MAKRIS FIELD REPORT**Date of Field Visit/Observations: 1 March 2019****Project: Holliston Library****Date of This Report: 3 March 2019**

Figure 1 - General Plan of Trusses (Linework Copied from RussoBarr Drawing)

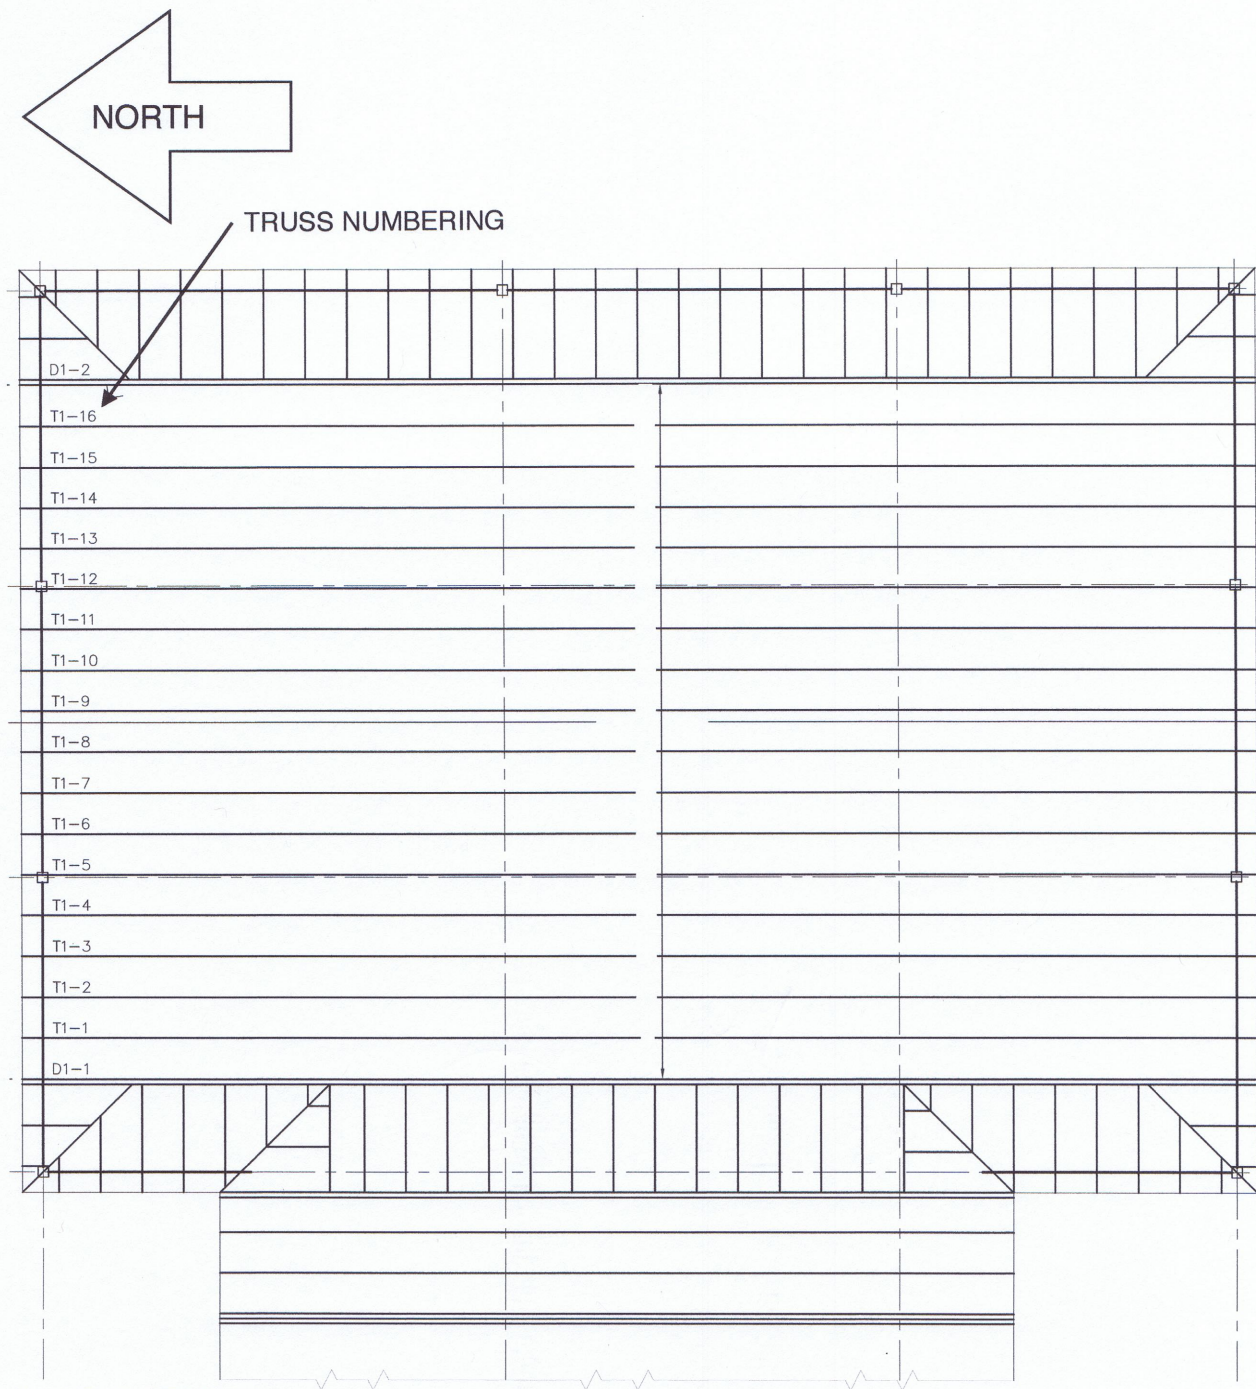
1. Note, for compass point orientation, the “front” entry of the Library facing Washington Street is assumed to be west elevation. See Figure 1 for the truss orientation plan.

2. 16 T1 single ply trusses are 24 inches on centers, nominal, as per the design drawings.
3. D1 double ply trusses are not equally spaced from the adjacent T1 truss; the westerly D1 is 1'-10" from the T1, while the easterly D1 is 1'-0" distant; the maximum will be used for analysis of the trusses.

Figure 2 - Panel Point Numbering, for T1 and D1 Trusses

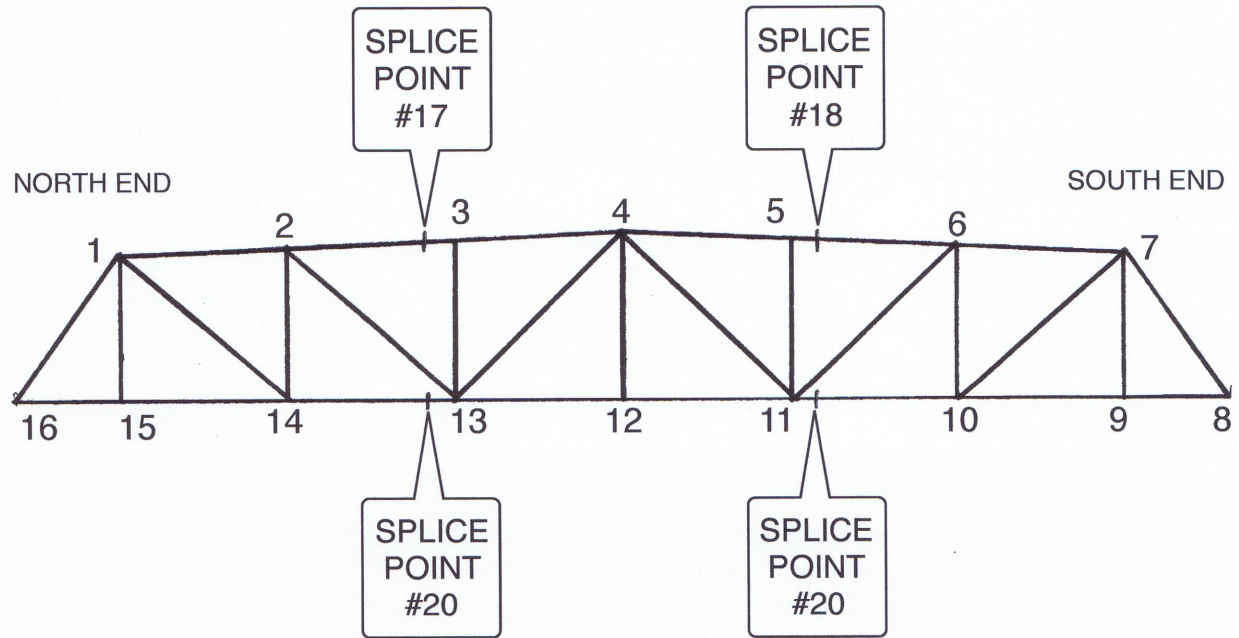
1. With the exception of panel points 8, 15 and 16 at the ends of trusses, many of the panel points of the T1 single ply trusses have some level of damage. Since the event leading to the damage is not fully understood, I recommend that all panel points except #8 and #16 be repaired with plywood gussets. See Figure 2 for panel points numbering.
